# Tivoli Mfg. Ltd.

## Safety Bulletin

**Bulletin No:** SOSA013

**Purpose:** Structural Inspection of sweep arms

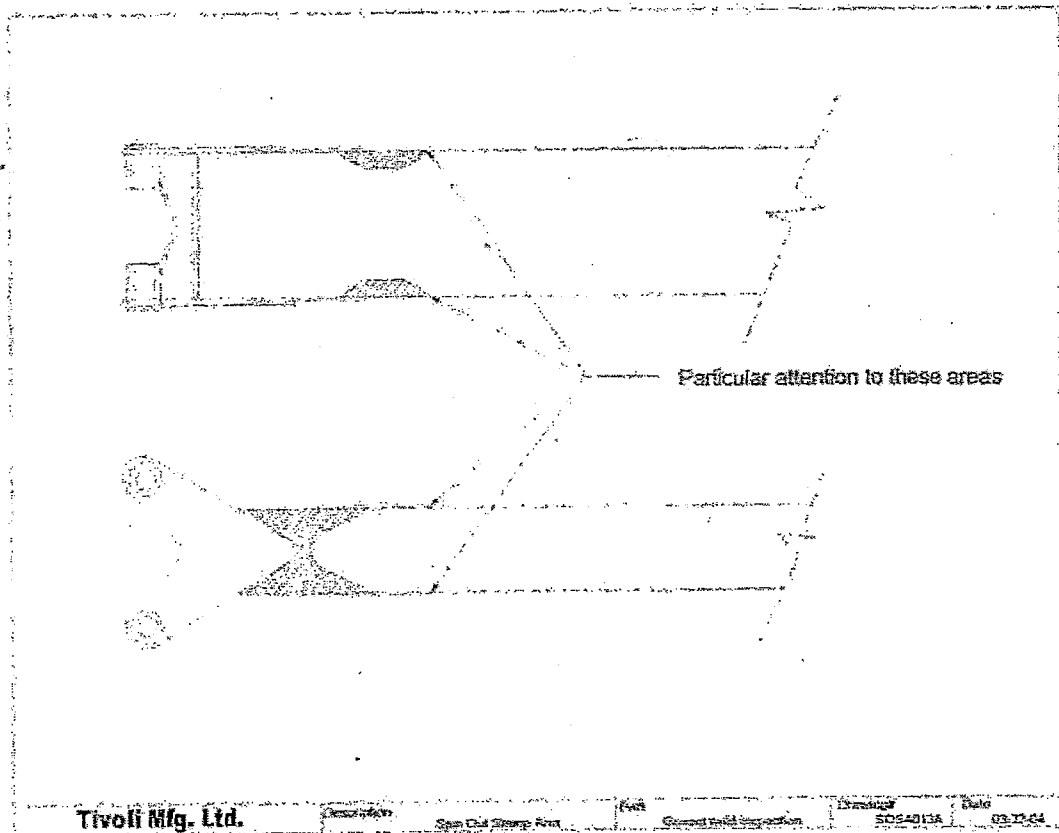
Inspect all sweep arm welds in addition to the welds installing the gusset kit using nondestructive (NDT) inspection techniques. The 400-hour NDT test requirements can include ultrasonic, magnetic particle, or dye penetrant inspection by a professional inspector.

Visually inspect all welds on the entire sweep length of each sweep arm. Pay particular attention to the tips of the side gussets as indicated in the attached drawing SOSA013A.
